EGG-PBS-6887

RADIOLOGICAL EFFLUENT TECHNICAL SPECIFICATIONS (RETS)
IMPLEMENTATION--ZION GENERATING STATION UNITS 1 AND 2

Published June 1985

Prepared for the
U.S. Nuclear Regulatory Commission
Washington, D.C. 20555
Under DOE Contract No. DE-AC07-76ID01570
FIN NO. A6459

Figure 1 Zion Station liquid radwaste effluent pathway.

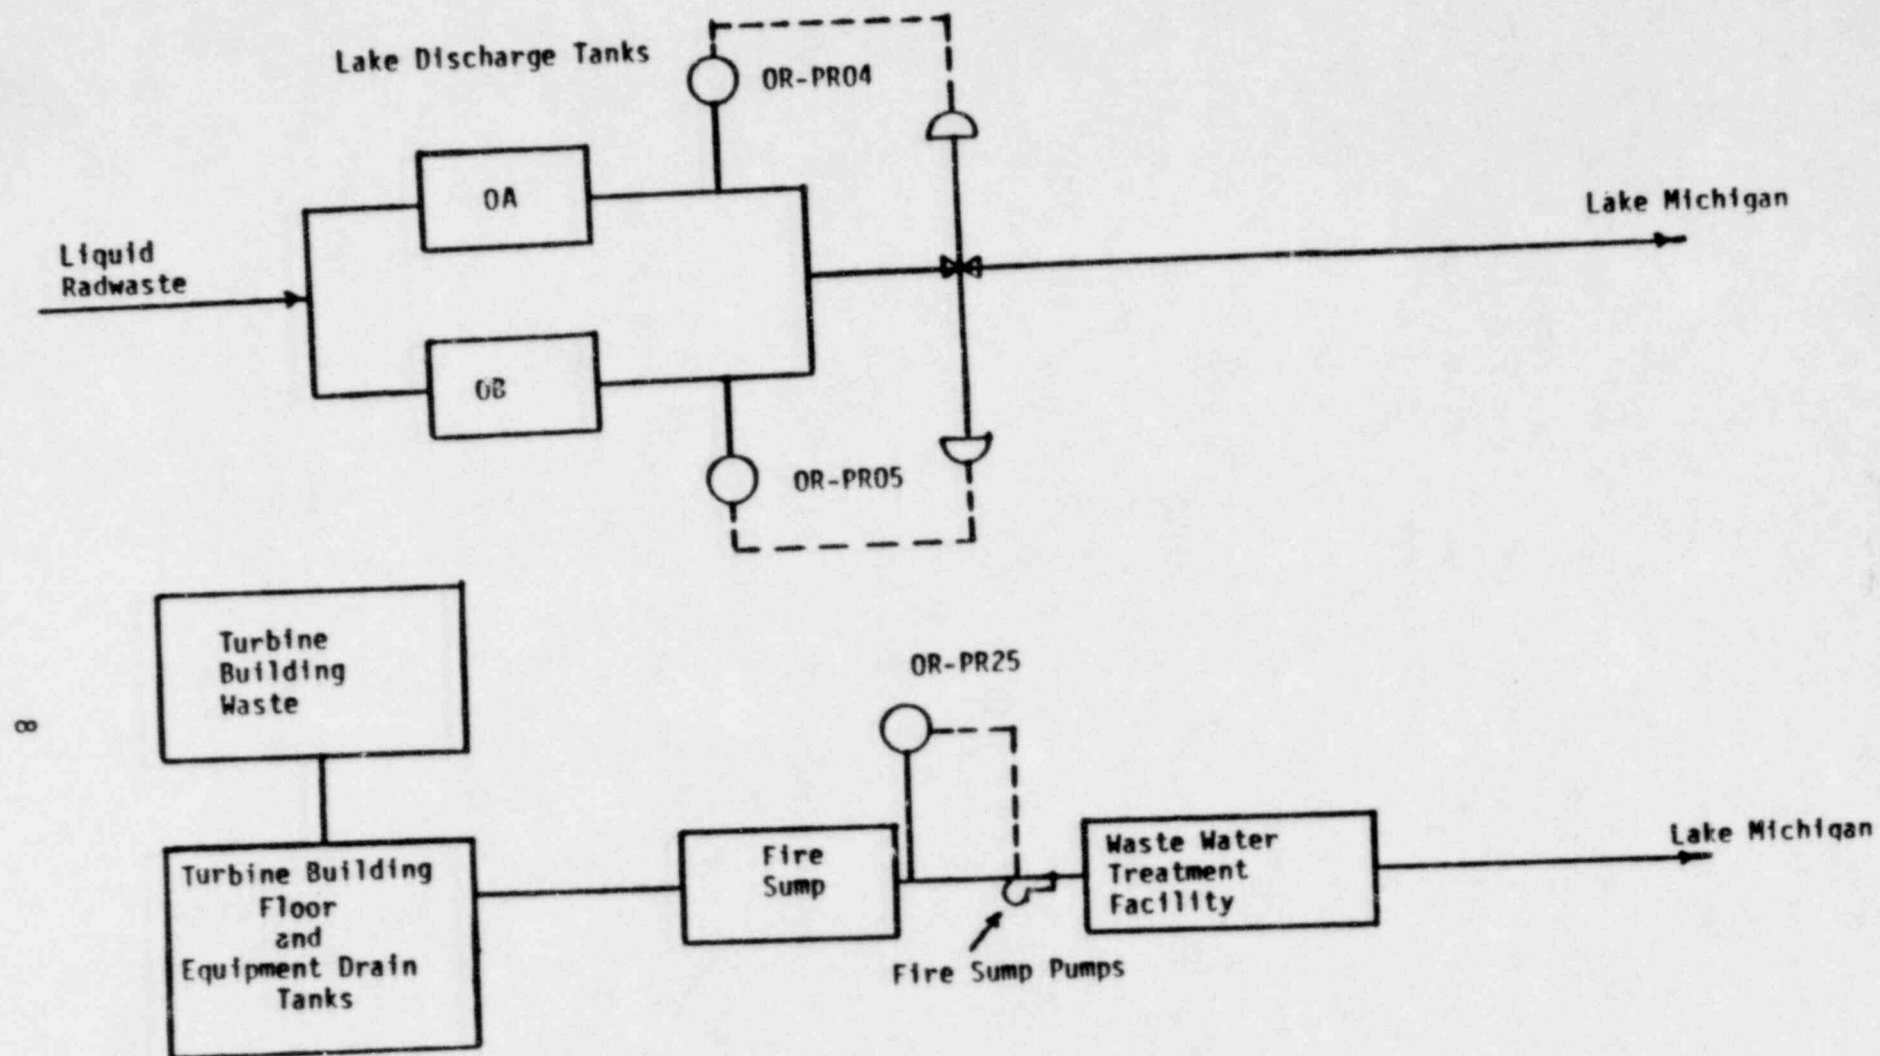
There are two radioactive effluent release points from the two-unit Zion Station as shown in Figure 1. The first release point is from batch releases from the Lake Discharge Tanks. Liquid radwaste from either unit is pumped to one of two Lake Discharge Tanks before batch release to Lake Michigan. The second release point is from the Waste Water Treatment Facility. Low-level radioactive liquid wastes from the fire sump is pumped to the Waste Water Treatment Facility before continuous release to Lake Michigan.

Instrument channels ORTPR04 and ORTPR05 are used to monitor all releases from the lake discharge tanks. On high alarm the monitor automatically initiates closure of a valve to prevent further release. The discharge valve is kept closed and tagged out of service at all times except during the discharge. The lake discharge tanks are sampled and quantified before release. The flow rate is determined from flow rate monitoring devices.

The discharge line from the fire sump pumps to the Waste Water Treatment Facility is continuously monitored by instrument channel ORTPR25. On high alarm the monitor automatically trips all of the fire sump pumps. The fire sump is sampled and quantified daily and the flow rate is determined based on pump capacity and run time.

Figure 2 Zion Station gaseous radwaste effluent pathways.

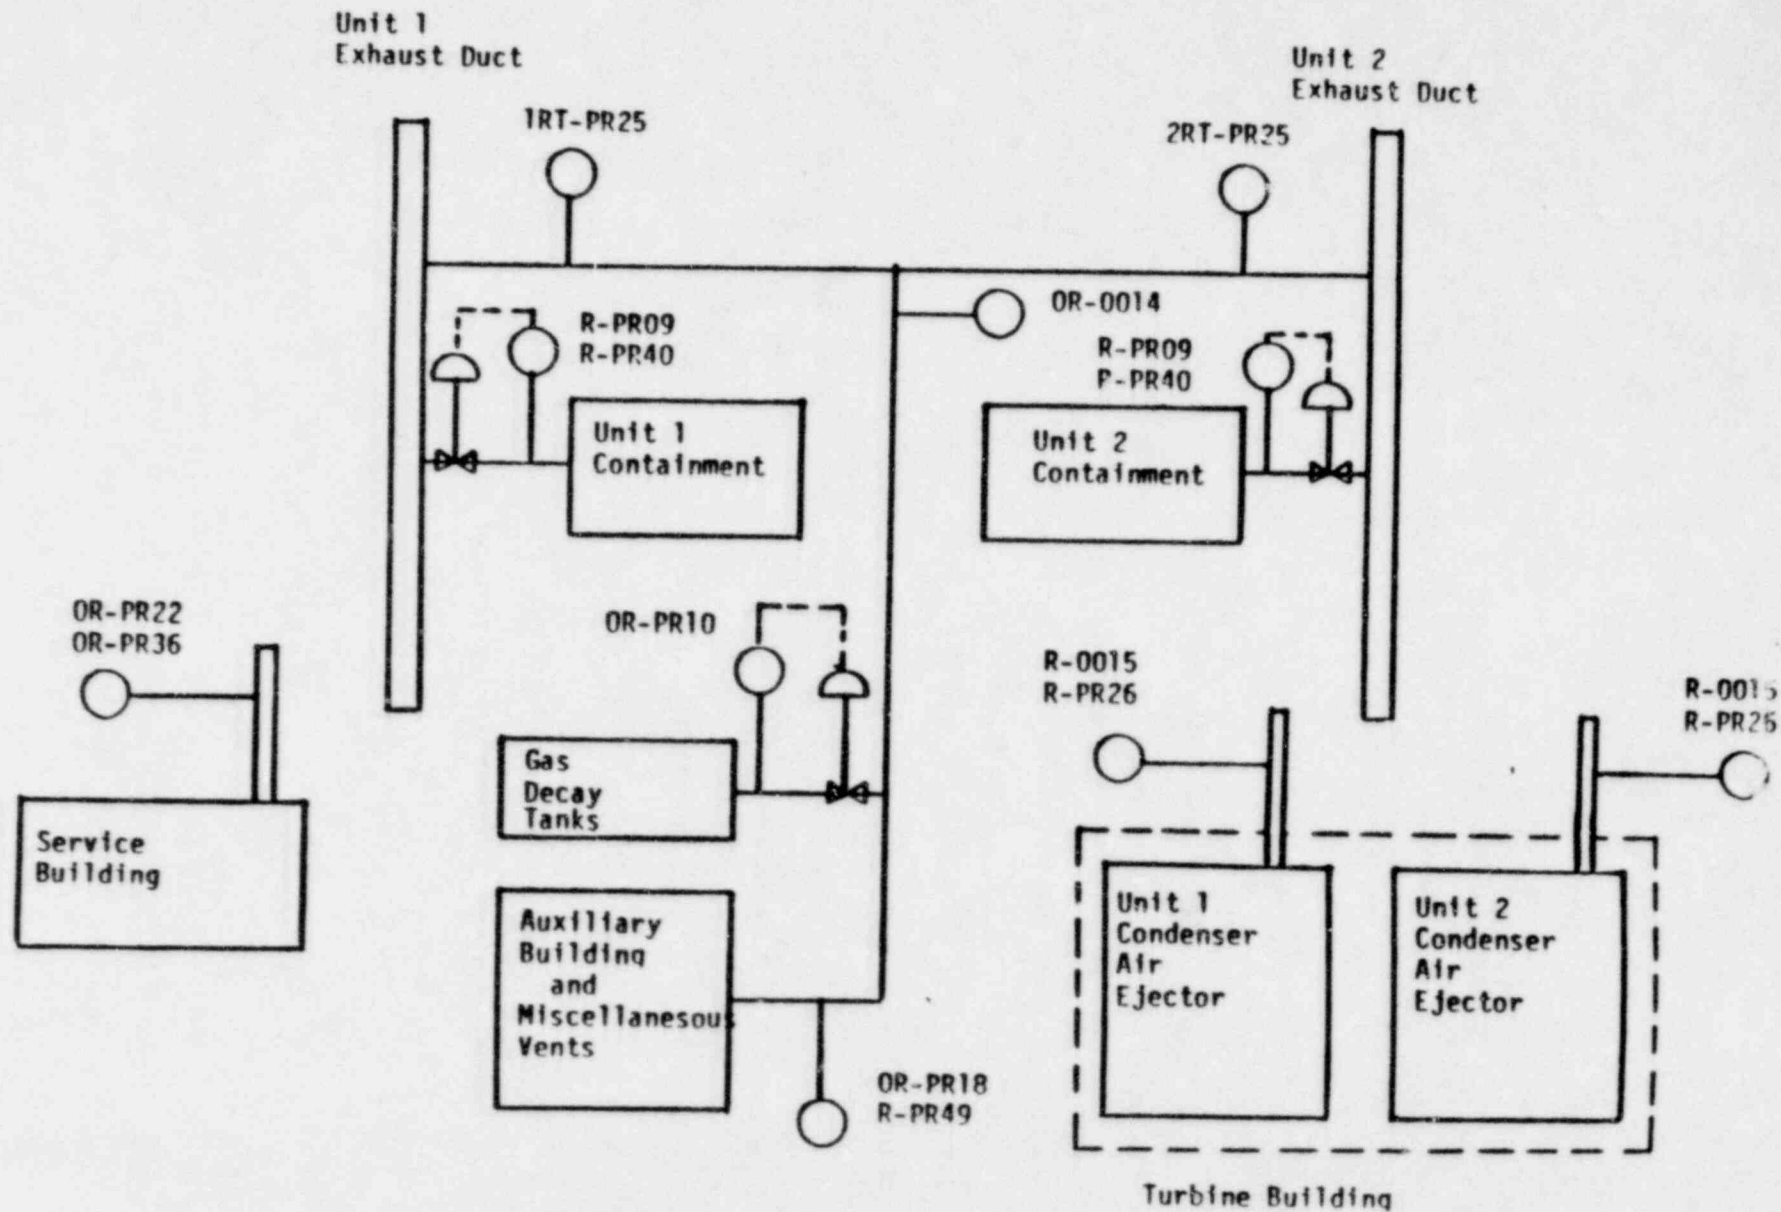
A block diagram of the radioactive gaseous release system is shown in Figure 2. As can be seen from Figure 2, effluents are collected in a common header before release from either the Unit 1 or Unit 2 exhaust duct. Consequently it is difficult to apportion the radioactivity between the two units and allocation will normally be made evenly between units.

The block diagram of Figure 2 shows the position of the gaseous effluent monitors. The waste gas decay tanks are monitored with noble gas monitors OR-PR10 and iodine and particulate monitors OR-PR10C. On high alarm the noble gas monitor automatically initiates termination of release. The flow rates are determined using flow rate measuring devices.

The auxiliary building ventilation and miscellaneous areas ventilation are released through the auxiliary building exhaust duct. On high alarm from the noble gas monitor the operator is alerted to take action that will reduce the release rate. The effluents are also monitored for iodine and particulate releases with OR-PR18 and R-PR49.

The air ejector effluents are monitored for noble gases with R-0015 and for iodine and particulate releases with R-PR26.

On high alarm, the containment purge noble gas monitors R-PR09A automatically initiate termination of release. The effluents are also monitored for iodine and particulate releases with instrument channels R-PR09 and R-PR40.

Service building effluents are monitored for noble gases with OR-PR22 and for iodine and particulates with OR-PR36.
